## CALIFORNIA COASTAL COMMISSION

February 27, 2001

**W 19a**

SUBJECT: **STAFF RECOMMENDATION ON CITY OF SAN DIEGO MAJOR LOCAL  
COASTAL PROGRAM AMENDMENT #4-2000 (CENTRE CITY—NORTH  
EMBARCADERO OVERLAY DISTRICT)**

## VIEW CORRIDOR STREETS

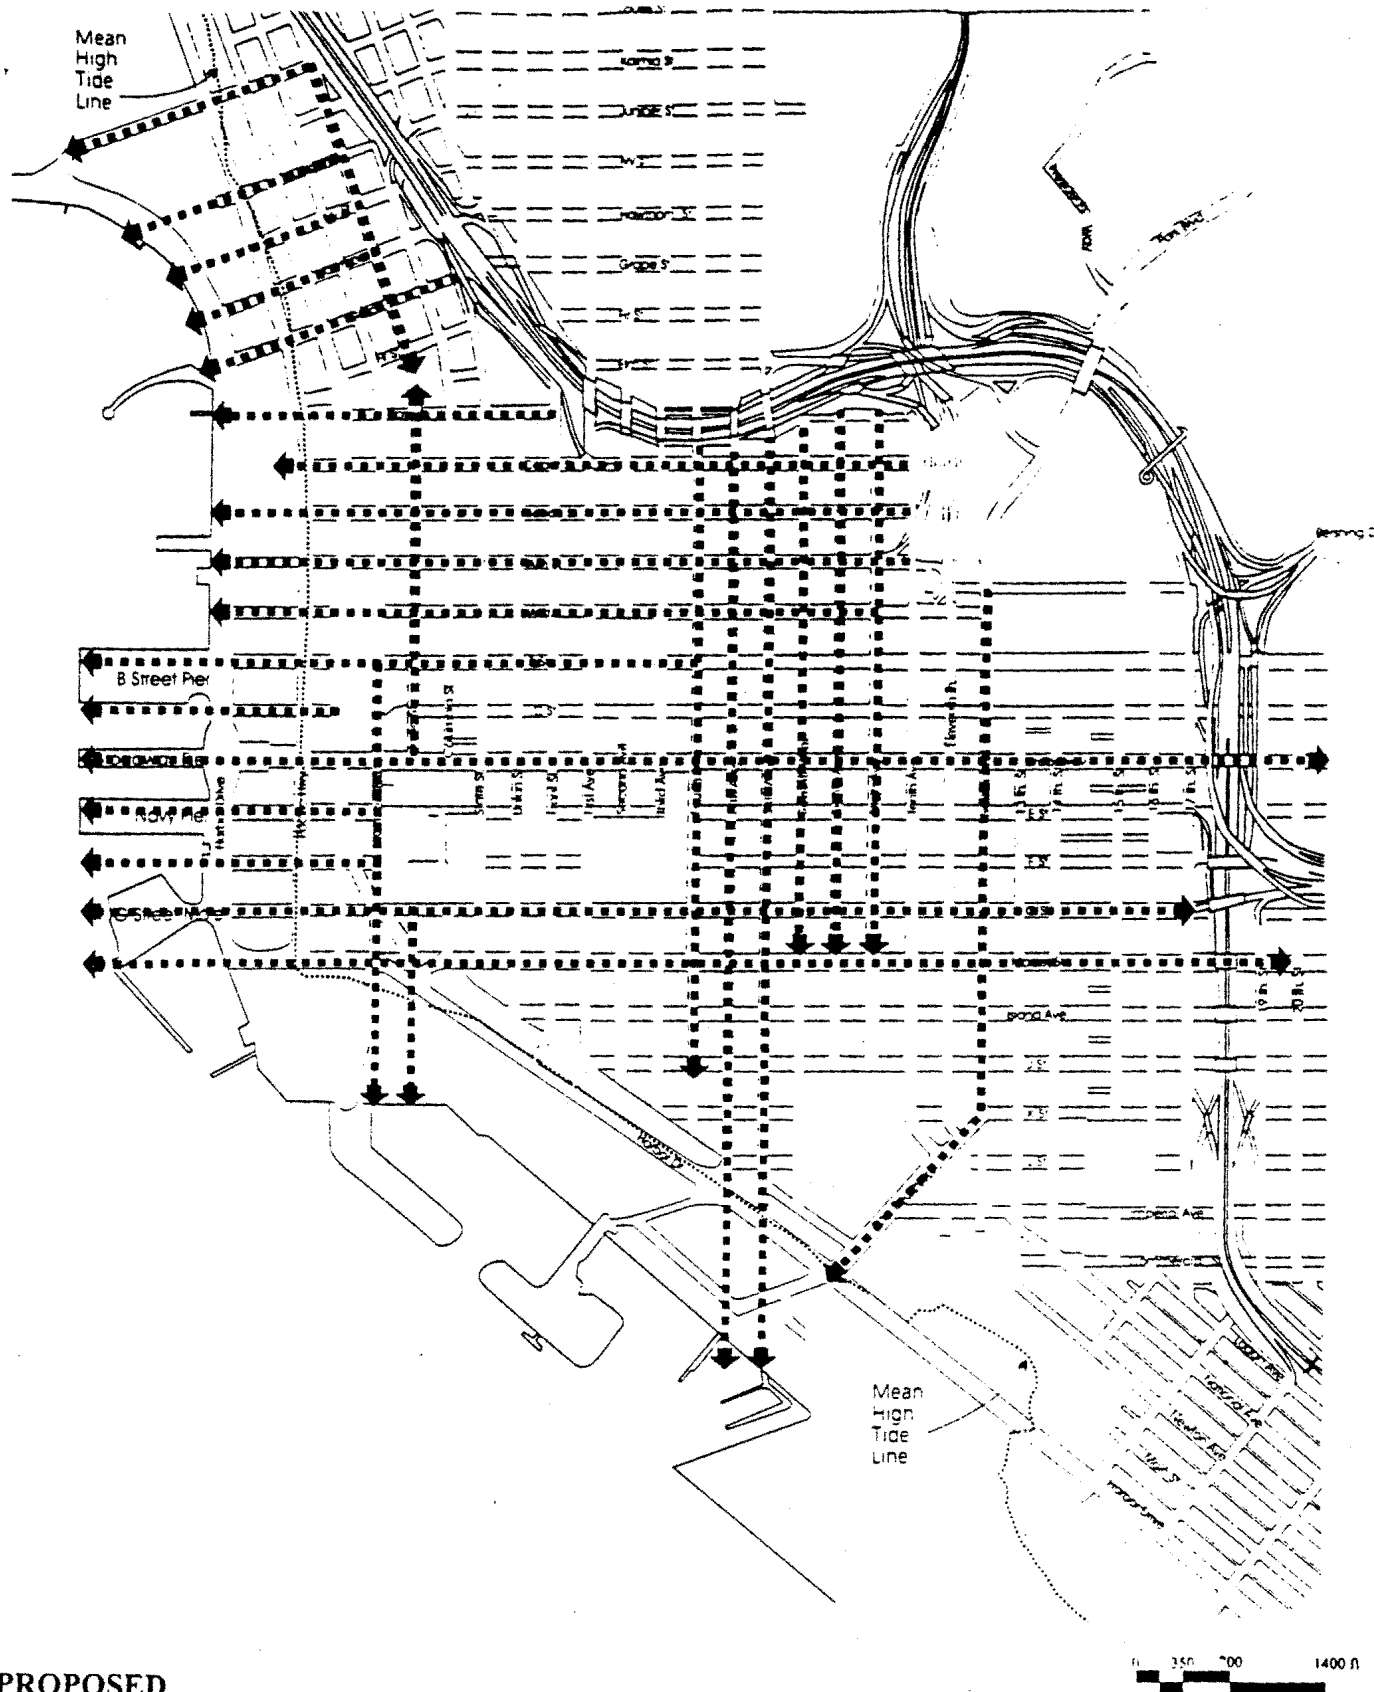
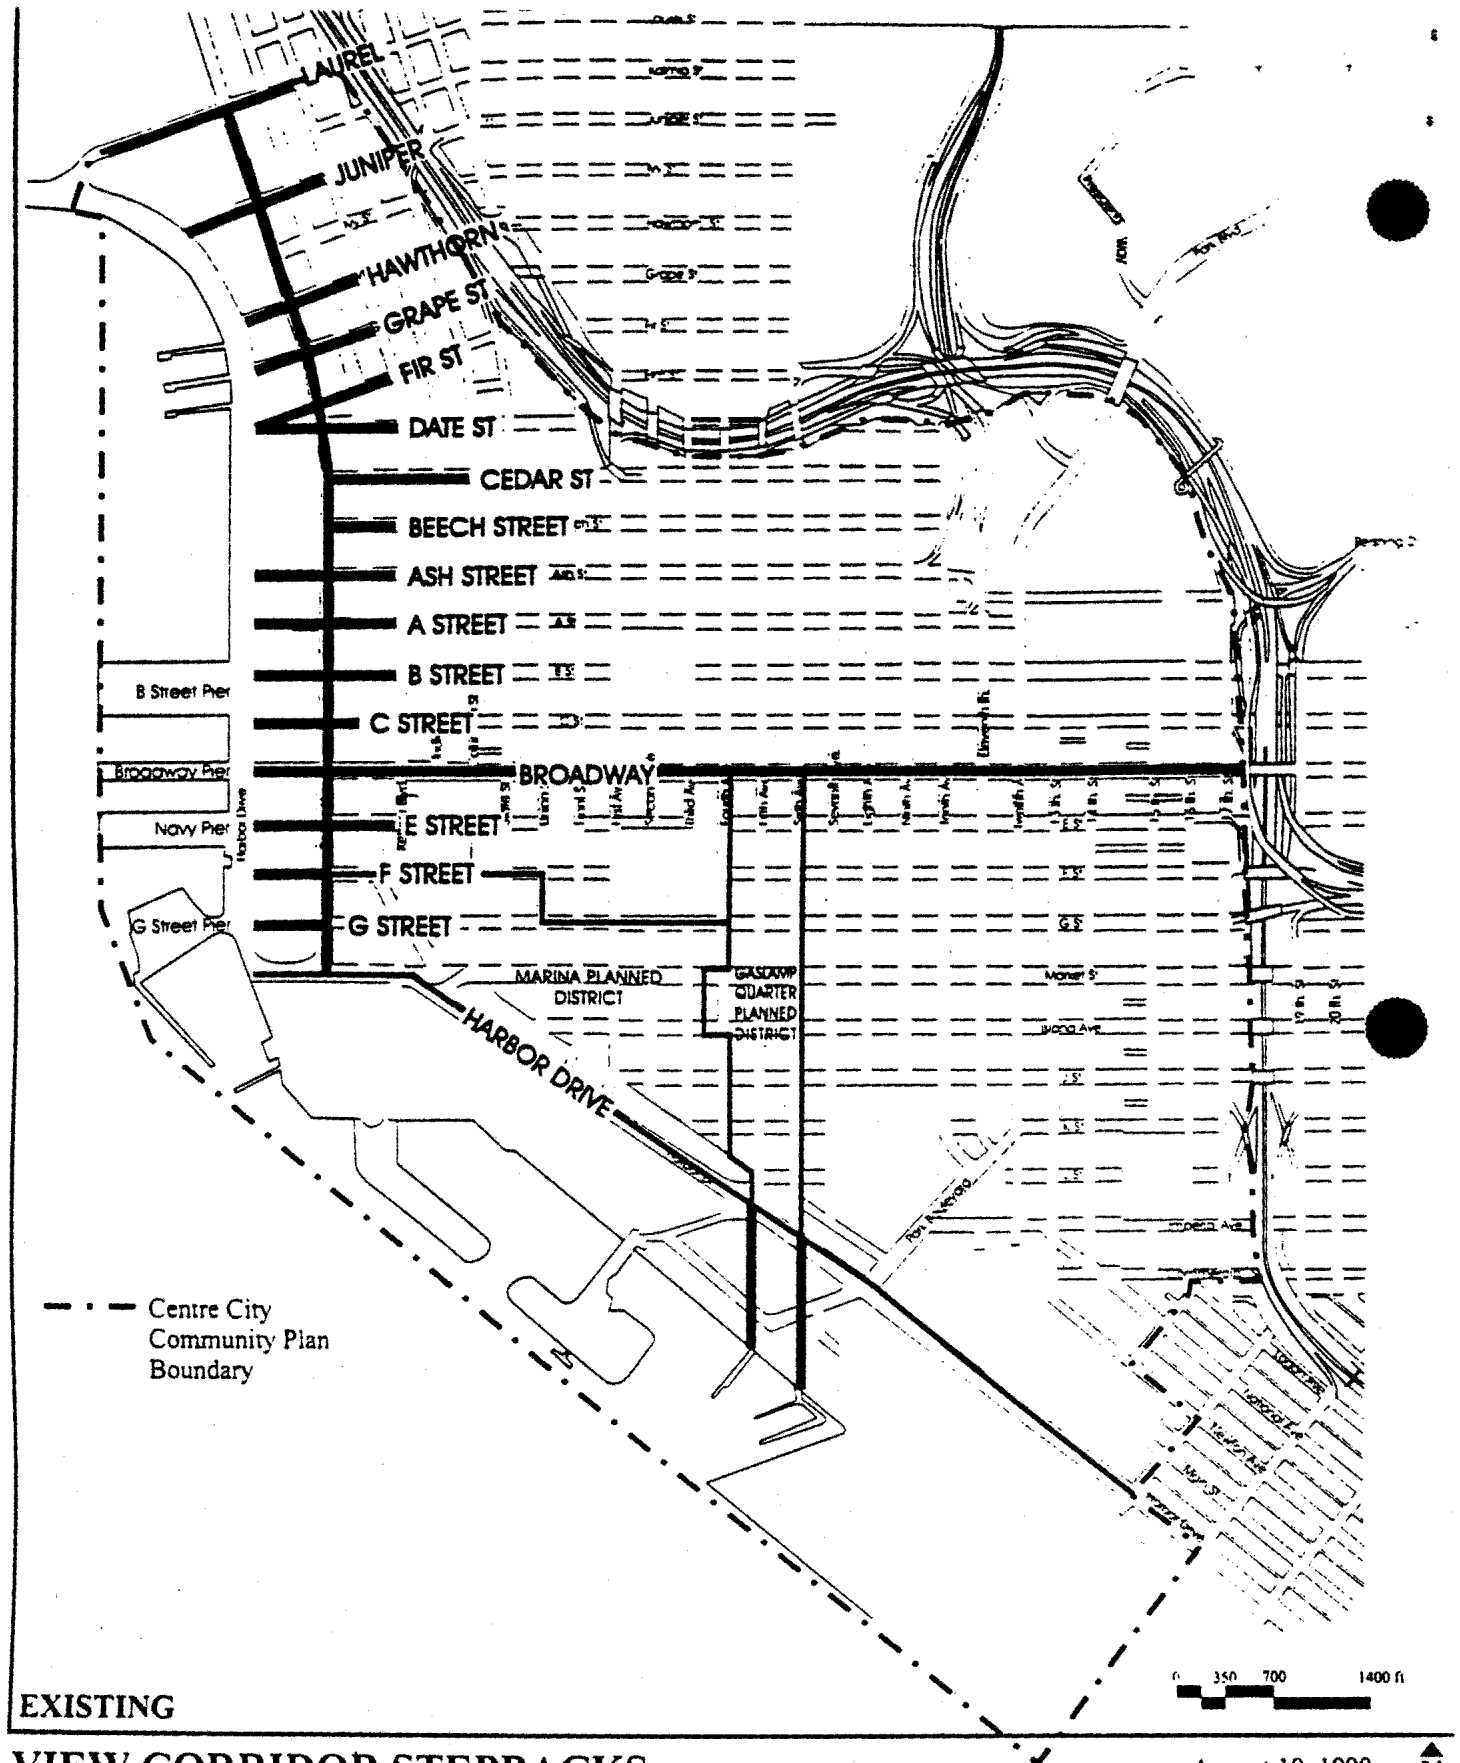
4. Figure 19, **VIEW CORRIDOR STREETS**, shall be revised to graphically depict Pacific Highway as a View Corridor Street from Date Street south to Pacific Highway's terminus (as shown on the existing Figure 19).

The plan would also make several changes to the existing View Corridors Streets shown on Figure 19. Ivy Street would be added as a View Corridor Street, and Pacific Highway is proposed to be removed as a view corridor. Designated view corridor streets are afforded special "stepback" protection to ensure that views from and along these streets are maintained. The City had originally proposed amending the View Corridors stepback table on page 45 of the LUP plan to alter the required stepbacks for several streets west of California Street, including Juniper, Hawthorn, Grape, Cedar, Ash, A, B, C, Broadway (both east and west of Kettner), E, F, and G. Since that time, the City has requested that the View Corridors table simply be deleted from the LUP, such that only the View Corridors stepback table in the PDO (as amended) would contain the required stepback distances and elevations (see Exhibit #15).

Proposed  
Building Height-North Embarcadero

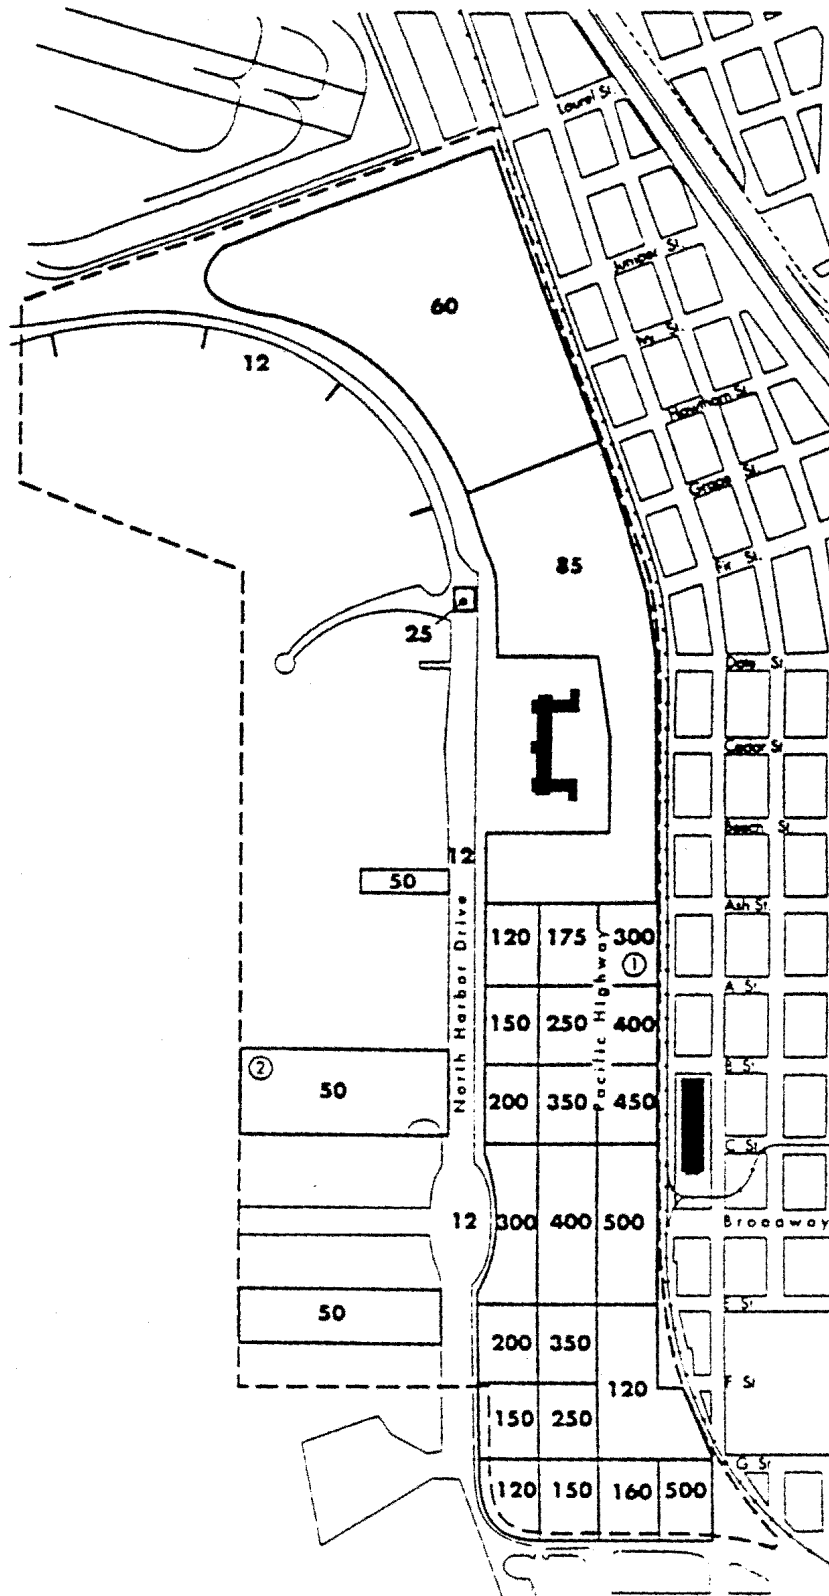
c) The figure shall be revised to eliminate any height limits on lands not within the City of San Diego's coastal permit jurisdiction; that is, any area west of Pacific Highway.

As discussed above, the proposed new Figure 4, "Building Height-North Embarcadero," includes height limits for areas within the Port District's permit jurisdiction. It is inappropriate to place specific development standards on properties outside the City's jurisdiction, since the standards cannot be implementing policies of a Land Use Plan which does not apply to the area. In addition, several of the proposed heights are inconsistent with the proposed PMPA, which *is* the standard of review for the area. Thus, Suggested Modification #7(c) removes all height limitations in the Centre City PDO (Figure 4) from land outside the City's jurisdiction.

**Figure 4.8**  
Stepbacks

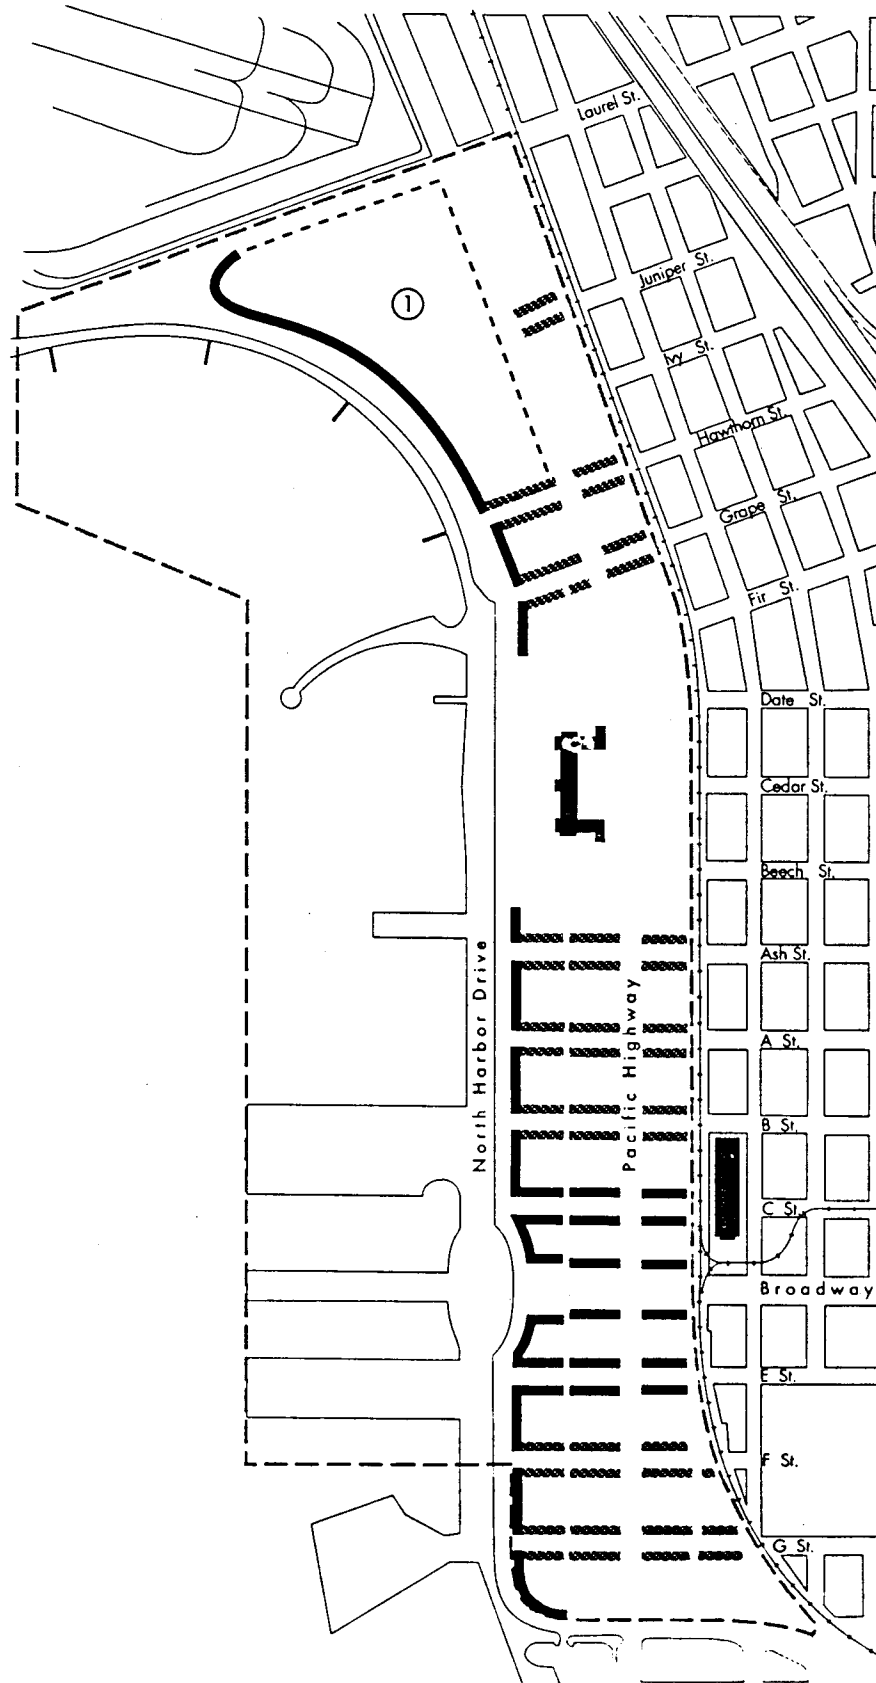
The City has requested several changes to the View Corridor Stepback exhibit, shown on Attachment 3 of Exhibit #15, that were not included in the City's initial amendment submittal. The changes include adding Beech Street west of Pacific Highway as a view corridor (and thus subject to the stepback requirements) and extending the view corridor on F Street from Pacific Highway east to Kettner Boulevard. These changes would increase the view protection on these streets, consistent with the policies of the Community Plan. Removal of Pacific Highway as a view corridor would be inconsistent with the Community Plan. Suggested Modification #9 includes the changes to the view corridors on Beech and F Streets, but requires that Pacific Highway remain a view corridor.
